# SAFETY RECALL BULLETIN

## NHTSA RECALL 17V-783, Transport Canada 2017-615

AUTOCAR, LLC SAFETY RECALL ACX-1704

Autocar has determined that a defect exists in the heating ventilation and air conditioning (HVAC) defrost mode door actuator circuit of certain 2017 and 2018 model-year Xpeditors, which could lead to an electrical short circuit.

Figure 2

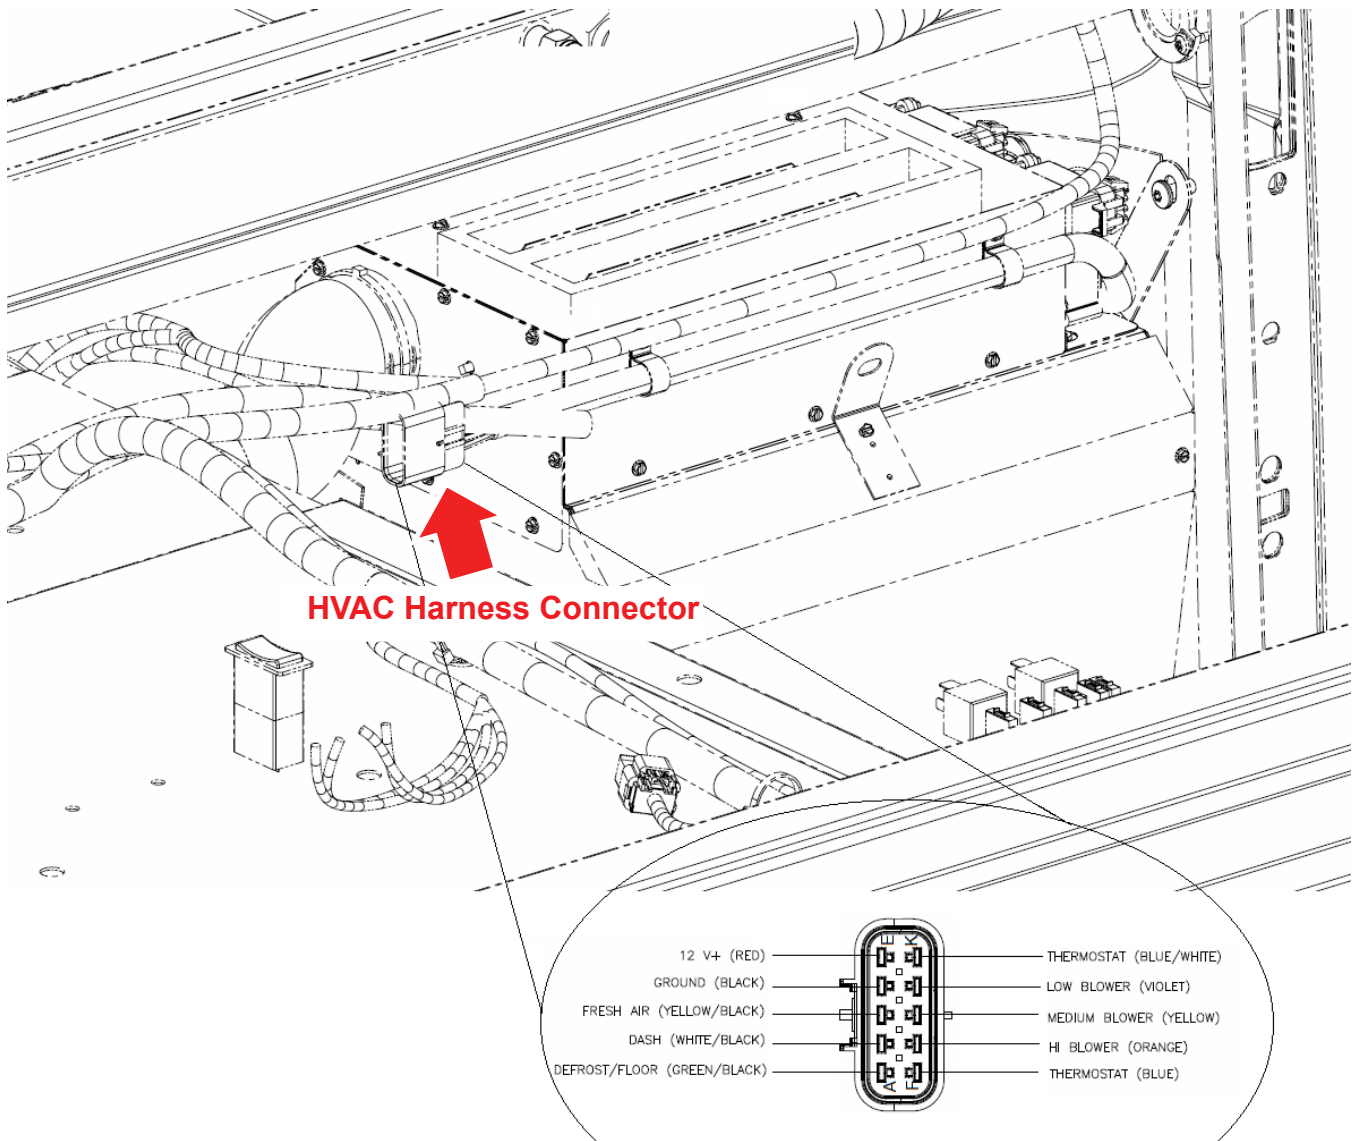
3. Locate the HVAC harness connector (*see Figure 2*).
4. Unplug the HVAC harness connector.

5. Inspect the HVAC harness. If the red and green wires are not in place, reinstall them as set forth in step 5a and 5b. If the red and green wires are in place, proceed to step 6.

**5a.)** From the harness side of the HVAC harness connector, insert the red wire into cavity E until it clicks into place.

**5b.)** From the harness side of the HVAC harness connector, insert the green wire into cavity A until it clicks into place.

6. Install the circuit protection harness (S6031001-002) and reconnect the HVAC unit.
7. Reinstall the access panel (or gauge pod) that was set aside in step 2.
8. Start the engine and test the HVAC defrost operation.
